TECHNICAL BULLETIN No. 62

SUBJECT: CP21AF1V

Fault: Switches to “Stand by” intermittently.

Fig. 1

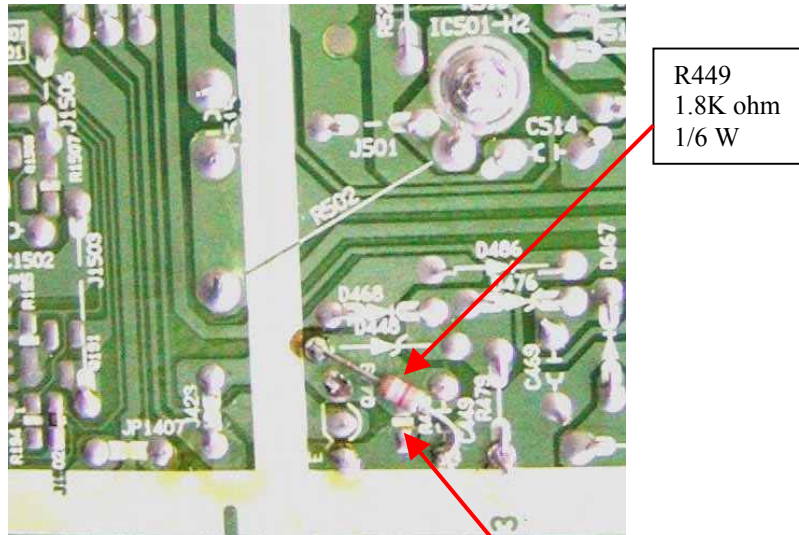
Cause: Loss of synchronisation between “Hold-down” and “Stand-by” circuit.

Remove R449 10K
Surface Mount

Remedy: Replace R449 10K ohm surface mount resistor to 1.8K ohm.

Method: If surface mount resistor is not available, a 1.8K ohm 1/6W resistor can be used. See Fig. 1 Below.
